**Bulletin No 2016-4 dated 1st July 2016 for the
HONDA GX160 CADET TECHNICAL REGULATIONS:**

Please note this bulletin reference item 4 of the Honda GX160 Technical Regulations V11a is amended with the following addition with immediate effect and supersedes Bulletin No 3 issued 16th June 2016:

4 Exhaust (for Honda Cadet DEP001) addition to regulation:

Some images of the upgrades are shown below.

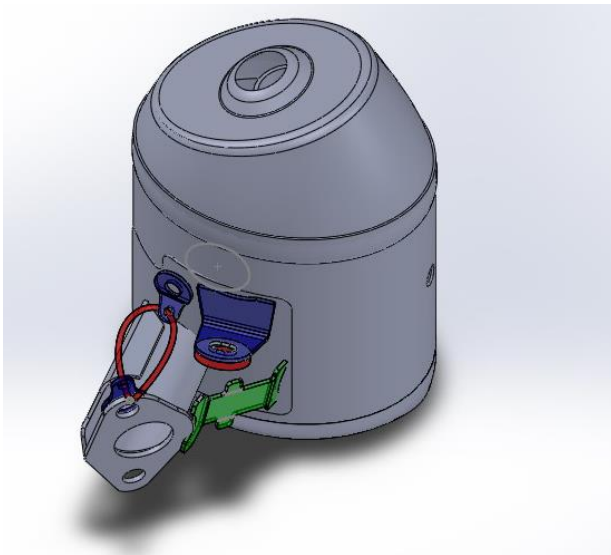
With effect from 29th July 2016 all DEP001 exhausts must have been upgraded* by the manufacturer with the following:

1. Additional welding on exhaust support plate
2. Additional support stay from flange to exhaust body (green)
3. Fixed leash/tether from an eyelet on the exhaust to the flange mounting stud
4. Addition support bracket (blue) with vibration washer (red)

The use of this mounting is not mandatory but is advised. This support bracket is designed to reduce the possibility of exhaust movement and eliminate any distortion to the exhaust flange. If used the vibration washer must be fitted between the exhaust bracket and the rocker cover. It is also advisable to fit a thread recovery procedure in the rocker cover mounting thread. Most engine preparers offer this service. (non-use of this bracket will invalidate any manufacturer's warranty).
